APPLICATION FOR URBAN DESIGN COMMISSION REVIEW AND APPROVAL

Document Number Document Title	*
ALTERATION TO AN APPROVED & RECORDED SPECIFIC IMPLEMENTATION PLAN City of Madison Date:	
Project Name: High Point Plaza	
Legal Description of Property:	
High Point Commercial Plat, Lot 3	
	Recording Arca

This letter is written to serve as a request for a minor alteration to the Approved and Recorded PCD (SIP) on the above named project. The current section of the zoning text which addresses signage for the property would be changed to modify occupant/tenant signable areas and include restrictions beyond the current City of Madison General Sign Ordinance as its standard for all wall signs.

SIGNAGE- ALTERATION TO AN APPROVED AND RECORDED PCD SIP 7617 MINERAL POINT ROAD MADISON, WI

A3.1

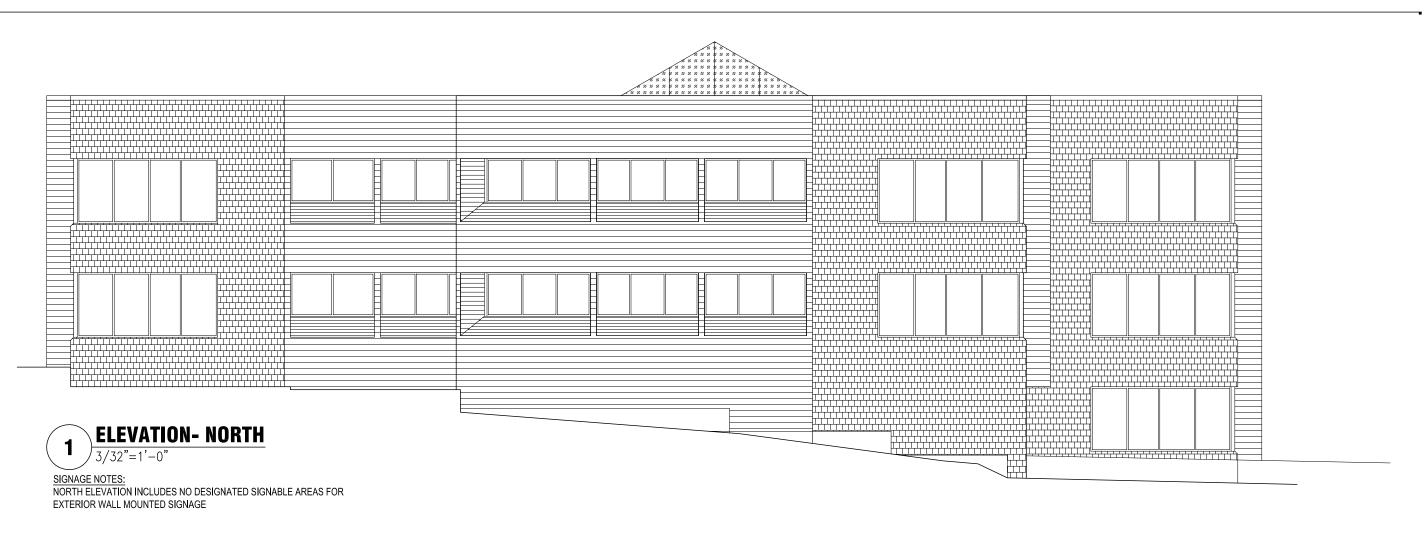
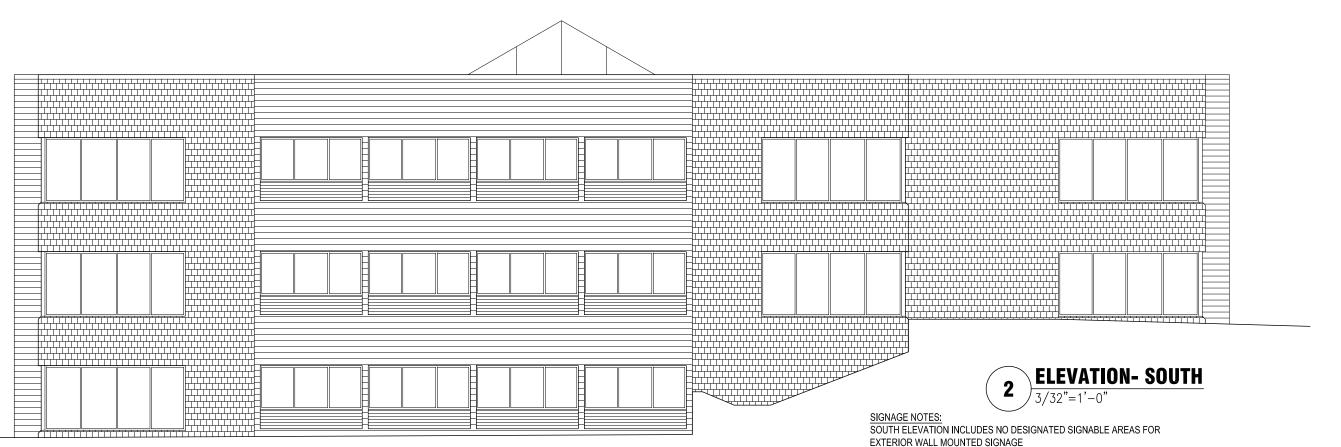
2. Property Address: 7617 Mineral Point Road	Name and Return Address;
The SIP for the above-described property is hereby amended by (description of change): Modify signage	
standards to designate areas for	Parcel Identification Number (PIN) 070826203039
exterior wall signs	
and shown on the Site Implementation Plans	s amended 11/21/1985
 This proposed amendment is authorized according to the SIP text record the Dane County Register of Deeds Office. 	ded as: Document No, in
The proposed alteration, as outlined above, is considered a minor alteration and is hereby approved by the Director of the Planning Unit of the Department of Planning and Development.	nk or FAXED copies please!
Alderperson Date Bradley J. Murph	ny, Director Date
Planning Unit, D Winer's Signature Planning Unit, D	cpt. of Planning & Development
State of Wisconsin County of Dane	
Personally came before me this day of day of Bradley J. Murphy, Director Planning Unit of the Department of Planning capacity and known double liters on who executed the foregoing ins	and Development, and acting in said trument.

"Building signs within this district will be permitted as allowed by the City of Madison General Sign Ordinances. Wall signs shall be restricted to locations within the designated signable areas on the second and third floors of the the East and West building facades as defined on the attached elevation drawings dated 03/08/2011. The occupant/tenant signage shall not be required to directly relate to the tenant space within the building when located within these designated signable areas. Ground signs will be limited to a total of 5 with a total combined area of 124 sf. Heights and dimensions shall be as shown on attached plans dated 10/18/85. Sign locations shall be as shown on attached site plan."
